**DEPARTMENT OF TRANSPORTATION**

Contract #: 04-0120F4Cty: SF/ALA Rte: 80 PM: 13.2/13.9File #: 69.25B**QUALITY ASSURANCE -- NON-CONFORMANCE REPORT****Location:** Changxing Island, Shanghai, P.R. China**Report No:** NCR-000646**Prime Contractor:** American Bridge/Fluor Enterprises, a JV**Date:** 23-Jan-2010**Submitting Contractor:** Zhenhua Port Machinery Company, Ltd (ZPMC), Changxing Island**NCR #:** ZPMC-0617**Type of problem:**

| <b>Procedural</b>   | <b>Procedural</b> | <b>Description:</b> Unapproved Buttering of Side Panel Splice Welds |                                    |

**Reference Description:** ZPMC performed unapproved buttering to correct root opening size on side panels for OBG Segment 12CE

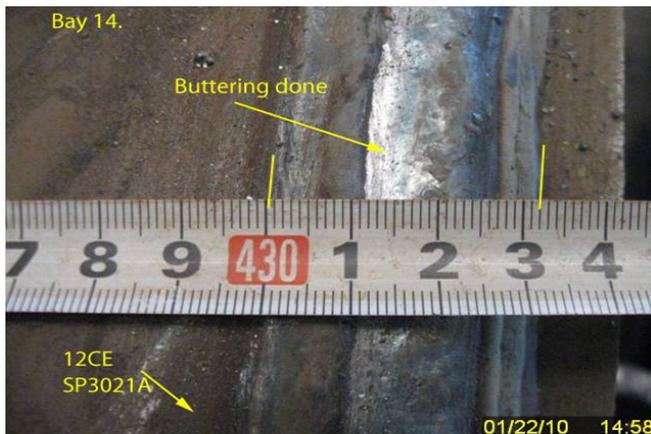
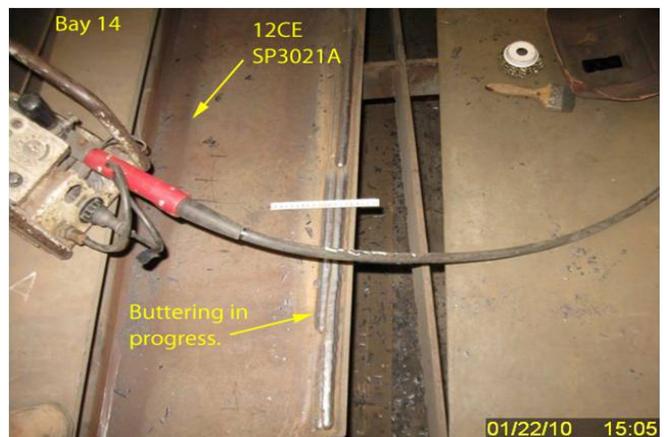
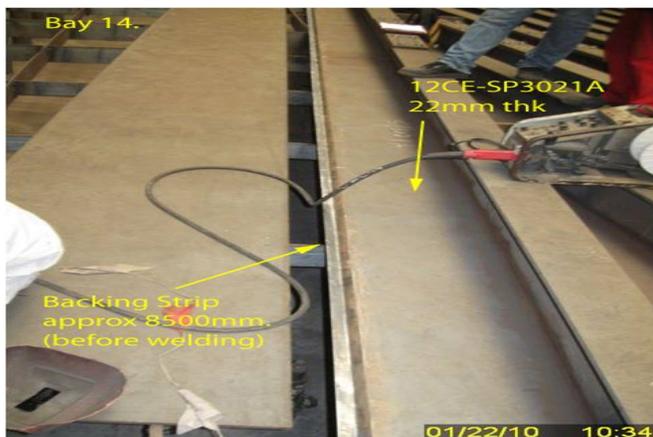
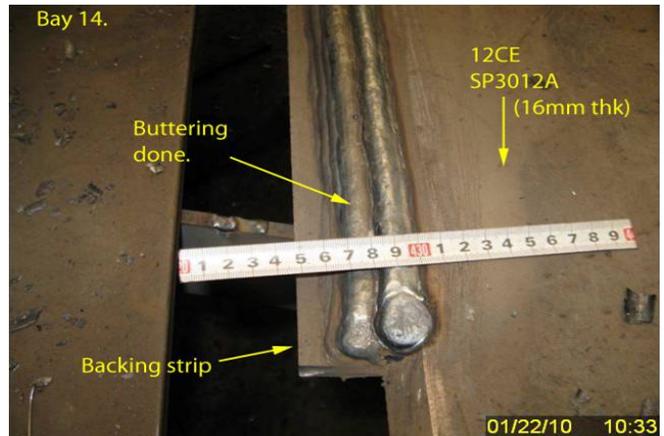
During random In-process Visual Inspection of OBG Segment 12CE, this Quality Assurance Inspector (QA) discovered the following issues:

- Deposition of weld metal (buttering/build up) of up to 21mm measured horizontally from the groove face to correct excessive root opening by Flux Cored Arc Welding (FCAW) without the prior approval of the engineer.
- Buttering was performed on Side Panel SP3012A (38mm x L=1500mm) and SP3021A (30mm x L=2000mm)
- ZPMC onsite Quality Control Inspector (QC), Mr. Guo Xing Hui, produced Welding Repair Report (WRR)-B-WR-10076 Dated January 9th, 2010 for the work being performed.
- The material being welded is Non SPCM.
- The Side Panel components are located in Bay 14.

For further information, please see the attached photos and applicable reference below.

AWS D1.5 (02) Section 3.3.4.2 – “Root openings larger than those allowed in 3.3.4.1 may be corrected by welding only with the approval of the Engineer”.

**Reference Resolution:** The weld built measured by the inspector was not in its final state. After grinding, the build up measured 15mm which is allowable by AWS D1.5. Based on this ZPMC requests closure of this NCR.

Approval pending MT, VT and UT.

Procedural  **Procedural**  **Description:** Unapproved Buttering of Side Panel Splice Welds

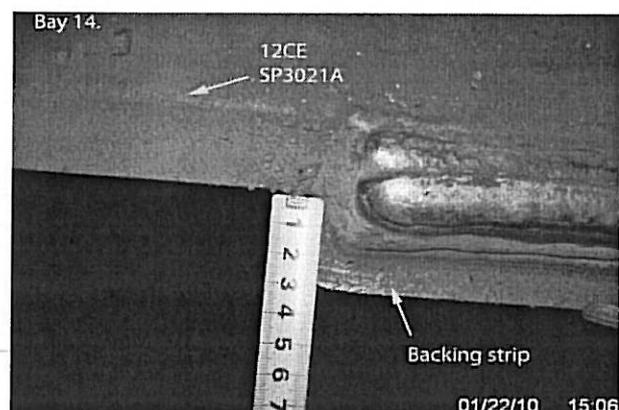
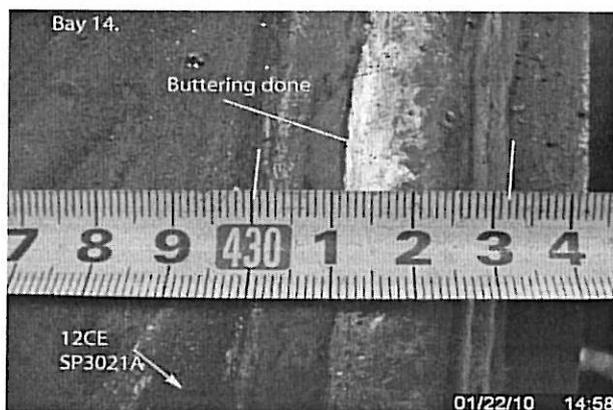
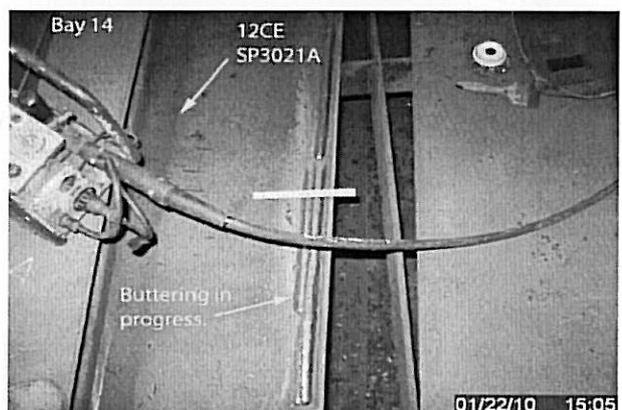
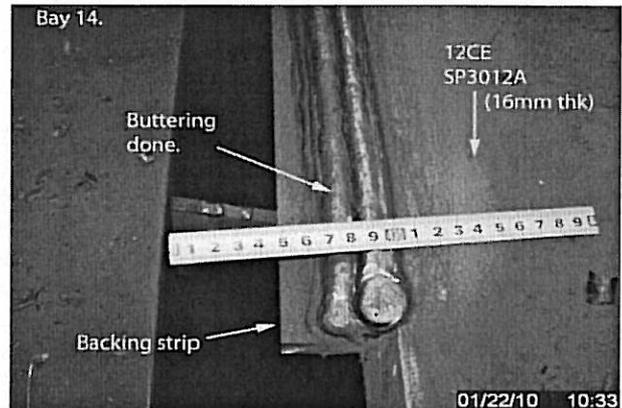
During random In-process Visual Inspection of OBG Segment 12CE, this Quality Assurance Inspector (QA) discovered the following issues:

- Deposition of weld metal (buttering/build up) of up to 21mm measured horizontally from the groove face to correct excessive root opening by Flux Cored Arc Welding (FCAW) without the prior approval of the engineer.
- Buttering was performed on Side Panel SP3012A (38mm x L=1500mm) and SP3021A (30mm x L=2000mm)
- ZPMC onsite Quality Control Inspector (QC), Mr. Guo Xing Hui, produced Welding Repair Report (WRR)-B-WR-10076 Dated January 9th, 2010 for the work being performed.
- The material being welded is Non SPCM.
- The Side Panel components are located in Bay 14.

For further information, please see the attached photos and applicable reference below.

AWS D1.5 (02) Section 3.3.4.2 – “Root openings larger than those allowed in 3.3.4.1 may be corrected by welding only with the approval of the Engineer”.

**Reference Resolution:** After grinding the horizontal height of the weld metal from the groove face was 15mm, which does not require the Engineer's approval. Based on this ZPMC requests closure this NCR.

Please provide a copy of the WRR used for this repair showing that the amount of weld metal deposited was 15mm as indicated.

**Description of welding discontinuity:**

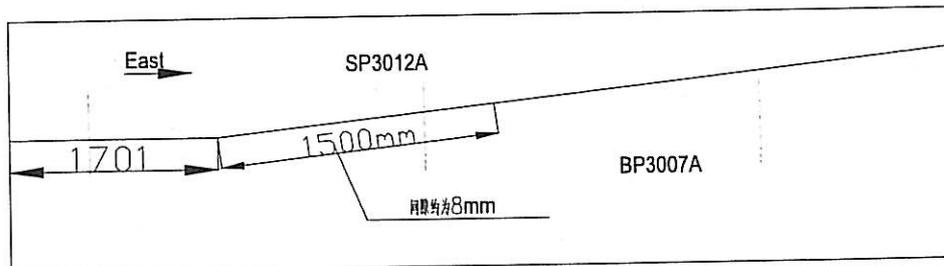
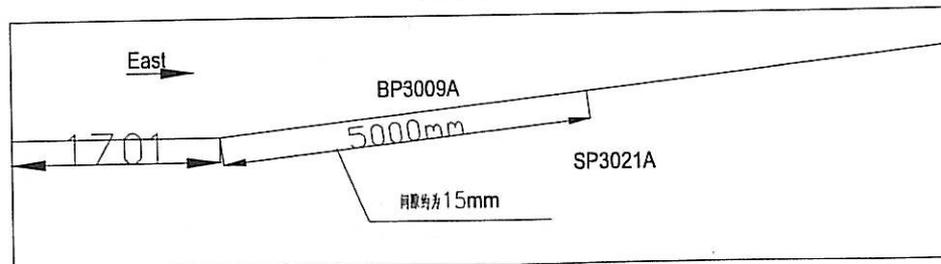
检查发现12CE的底板BP3007A与SP3012A的拼缝间隙超标, 最大8mm, 长度约为1500mm, 底板BP3009A与SP3021A的拼缝间隙超标, 最大15mm, 长度约为5000mm, 具体如下图所示  
After inspection 12CE bottom plate gap at BP3007A and SP3012A, the gap was maximum 8mm, 1500m in length, maximum 15mm at BP3009A and SP3021A, the detail sees the following draft.

焊接变形和制作误差。

Weld distortion and fabricate error.

1. Grind the edge of the repair area cleanly;
2. Prepare an right joint according to the approved WPS;
3. Perform VT to the repair area to ensure no impurity exist;
4. Add steel backing according to the attached drawing 1;
5. Preheat and weld according to the relevant repaired WPS;
6. Remove the steel backing and grind the weld flush with around metal;
7. Perform post NDT (VT MT UT) of repaired area to insure sound weld metal has been de posited.
8. Prepare excavation again according to the shop drawings

**Enhance supervision in process of fabrication to reduce error.**

Procedural  Procedural  Description: Unapproved Buttering of Side Panel Splice Welds

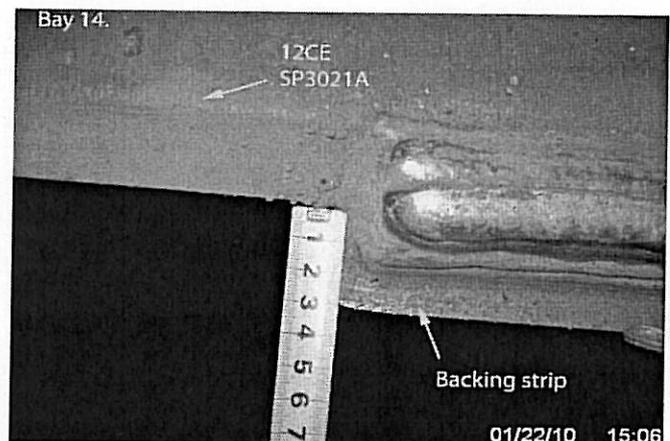
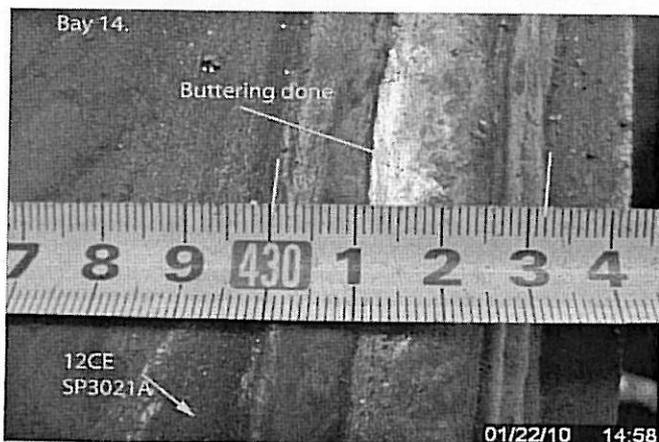
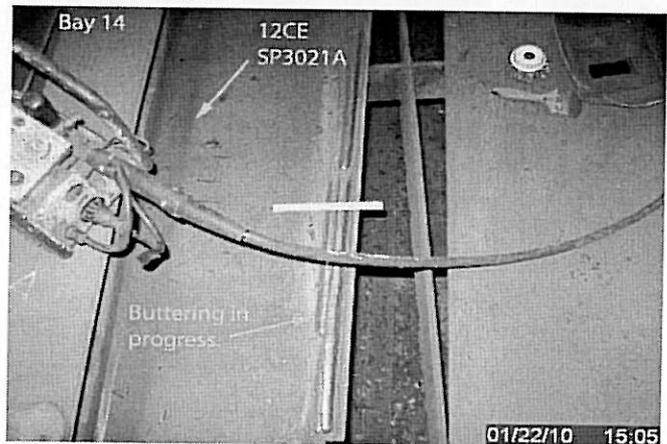
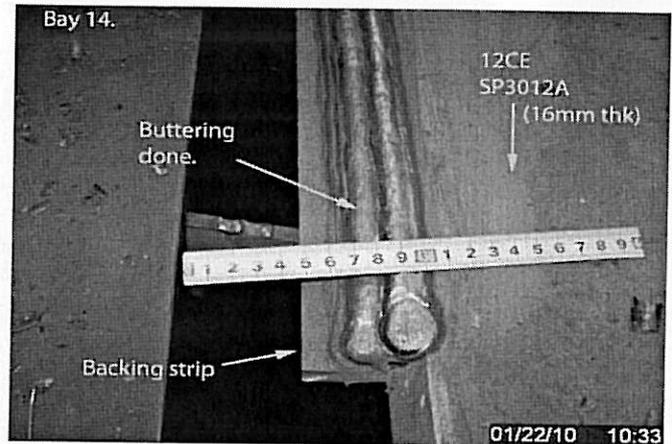
During random In-process Visual Inspection of OBG Segment 12CE, this Quality Assurance Inspector (QA) discovered the following issues:

- Deposition of weld metal (buttering/build up) of up to 21mm measured horizontally from the groove face to correct excessive root opening by Flux Cored Arc Welding (FCAW) without the prior approval of the engineer.
- Buttering was performed on Side Panel SP3012A (38mm x L=1500mm) and SP3021A (30mm x L=2000mm)
- ZPMC onsite Quality Control Inspector (QC), Mr. Guo Xing Hui, produced Welding Repair Report (WRR)-B-WR-10076 Dated January 9th, 2010 for the work being performed.
- The material being welded is Non SPCM.
- The Side Panel components are located in Bay 14.

For further information, please see the attached photos and applicable reference below.

AWS D1.5 (02) Section 3.3.4.2 – “Root openings larger than those allowed in 3.3.4.1 may be corrected by welding only with the approval of the Engineer”.

**Reference Resolution:** Per the Engineer's request ZPMC is submitting the WRR used when performing the weld build up. Based on this ZPMC requests closure of this NCR.

Please provide NDT results from UT specified in the WRR.

Procedural  Procedural  Description: Unapproved Buttering of Side Panel Splice Welds

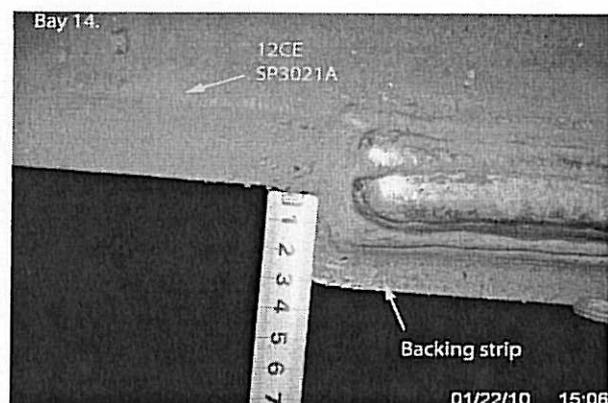
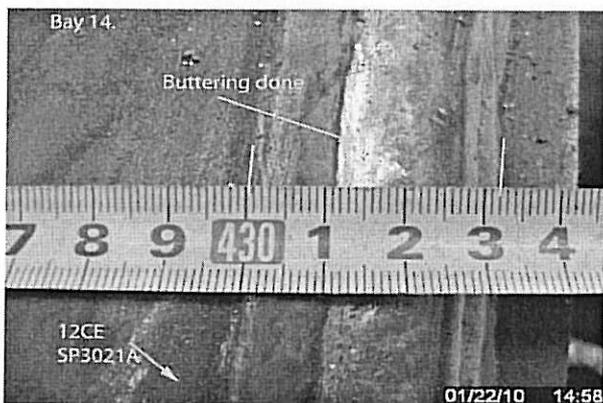
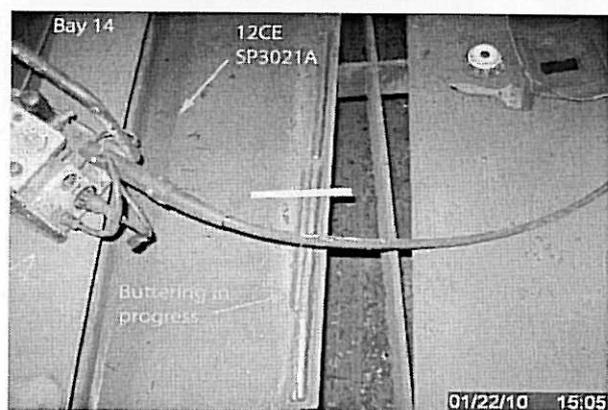
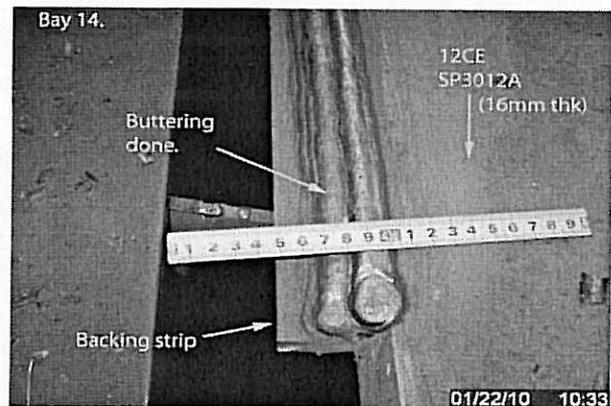
During random In-process Visual Inspection of OBG Segment 12CE, this Quality Assurance Inspector (QA) discovered the following issues:

- Deposition of weld metal (buttering/build up) of up to 21mm measured horizontally from the groove face to correct excessive root opening by Flux Cored Arc Welding (FCAW) without the prior approval of the engineer.
- Buttering was performed on Side Panel SP3012A (38mm x L=1500mm) and SP3021A (30mm x L=2000mm)
- ZPMC onsite Quality Control Inspector (QC), Mr. Guo Xing Hui, produced Welding Repair Report (WRR)-B-WR-10076 Dated January 9th, 2010 for the work being performed.
- The material being welded is Non SPCM.
- The Side Panel components are located in Bay 14.

For further information, please see the attached photos and applicable reference below.

AWS D1.5 (02) Section 3.3.4.2 – “Root openings larger than those allowed in 3.3.4.1 may be corrected by welding only with the approval of the Engineer”.

The NDT report provided with the NPR is for PL3069S and not PL3069A that is the subject of the NCR. This proposed resolution is accepted, action pending. Please provide NDT results for buttering performed on PL3069A.

ZPMC is providing the NDT records to show the acceptance of the buttering. Based on this, ZPMC is requesting closure of this NCR.

**Draft of welding discontinuity:**

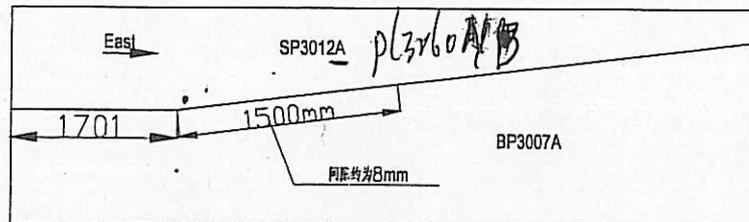
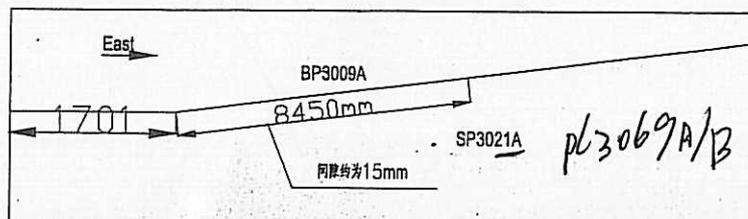
检查发现12CE的底板BP3007A与SP3012A的拼缝间隙超标, 最大8mm, 长度约为1500mm, 底板BP3009A与SP3021A的拼缝间隙超标, 最大15mm, 长度约为8450mm, 具体如下图所示  
 After inspection 12CE bottom plate gap at BP3007A and SP3012A, the gap was maximum 8mm, 1500m in length, maximum 15mm at BP3009A and SP3021A, the detail sees the following draft.

1. Grind the edge of the repair area cleanly;
2. Prepare an right joint according to the approved WPS;
3. Perform VT to the repair area to ensure no impurity exist;
4. Add steel backing according to the attached drawing 1;
5. Preheat and weld according to the relevant repaired WPS;
6. Remove the steel backing and grind the weld flush with around metal;
7. Perform post NDT (VT MT UT) of repaired area to insure sound weld metal has been de posited.
8. Prepare excavation again according to the shop drawings

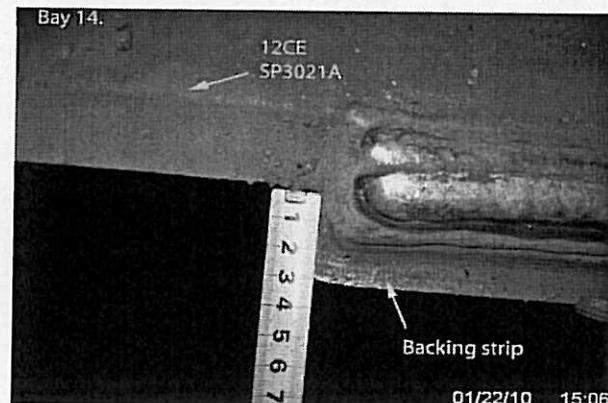
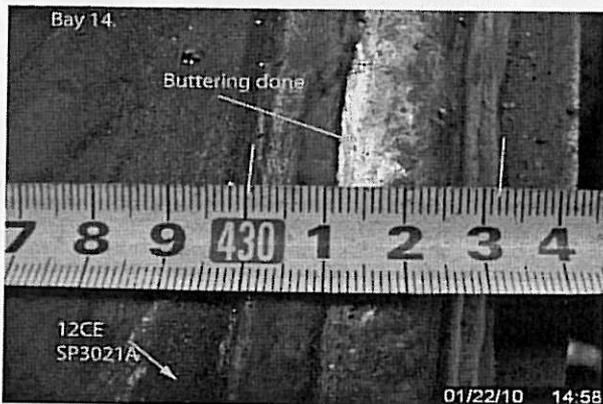
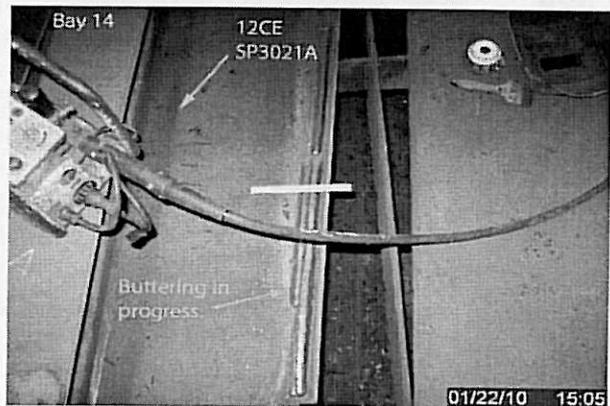
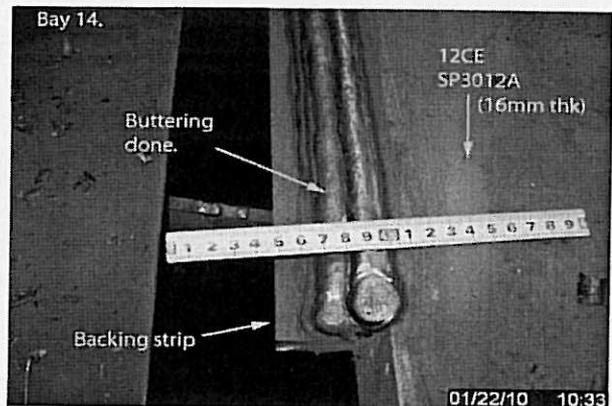
- Deposition of weld metal (buttering/build up) of up to 21mm measured horizontally from the groove face to correct excessive root opening by Flux Cored Arc Welding (FCAW) without the prior approval of the engineer.
- Buttering was performed on Side Panel SP3012A (38mm x L=1500mm) and SP3021A (30mm x L=2000mm)
- ZPMC onsite Quality Control Inspector (QC), Mr. Guo Xing Hui, produced Welding Repair Report (WRR)-B-WR-10076 Dated January 9th, 2010 for the work being performed.
- The material being welded is Non SPCM.
- The Side Panel components are located in Bay 14.

For further information, please see the attached photos and applicable reference below.

Previously submitted NDT documents were for the incorrect plates. ZPMC is submitting NDT documents with the correct plates to show that the weld up is acceptable. ABFJV has had discussions with the ZPMC QA Manager and he has agreed to increase CWI presence in all areas to prevent lapse in QC oversight in the future. Based on these actions and submitted documents, ZPMC requests closure of this NCR.

The preventative measures taken by the QCM is acceptable. The area has been repaired and NDT documents with the correct plates have been submitted. This NCR is considered closed.

Procedural  **Description:** Unapproved Buttering of Side Panel Splice Welds

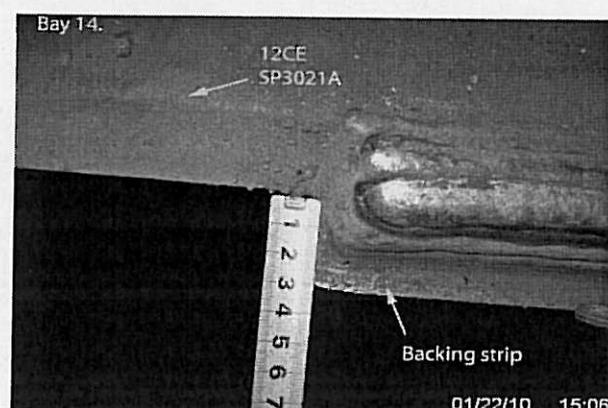
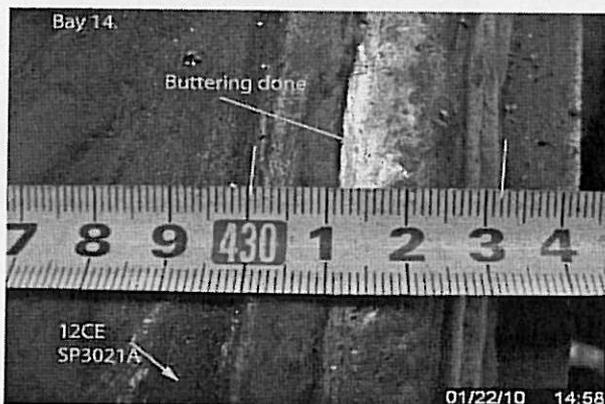
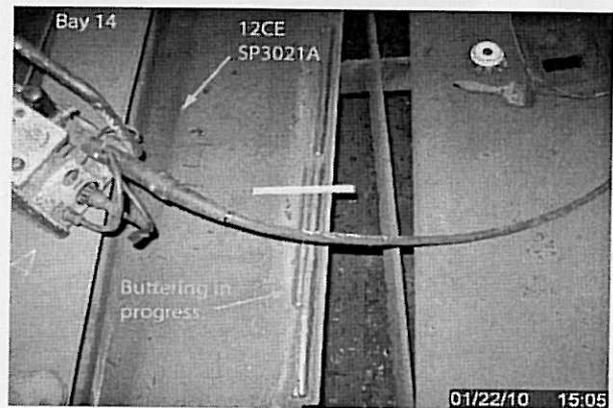
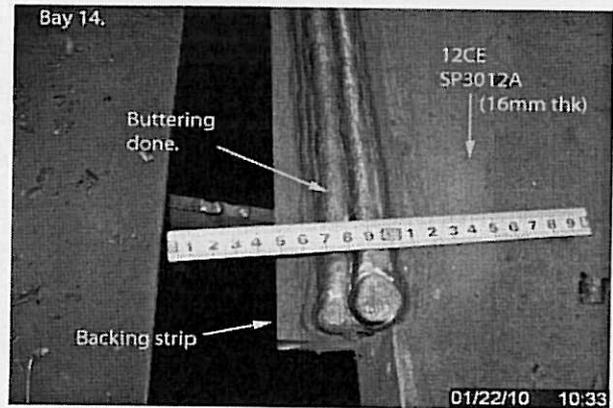
- Deposition of weld metal (buttering/build up) of up to 21mm measured horizontally from the groove face to correct excessive root opening by Flux Cored Arc Welding (FCAW) without the prior approval of the engineer.
- Buttering was performed on Side Panel SP3012A (38mm x L=1500mm) and SP3021A (30mm x L=2000mm)
- ZPMC onsite Quality Control Inspector (QC), Mr. Guo Xing Hui, produced Welding Repair Report (WRR)—B-WR-10076 Dated January 9th, 2010 for the work being performed.
- The material being welded is Non SPCM.
- The Side Panel components are located in Bay 14.

For further information, please see the attached photos and applicable reference below.

Provide WRR used during repair work along with subsequent NDT documentation verifying weld quality.
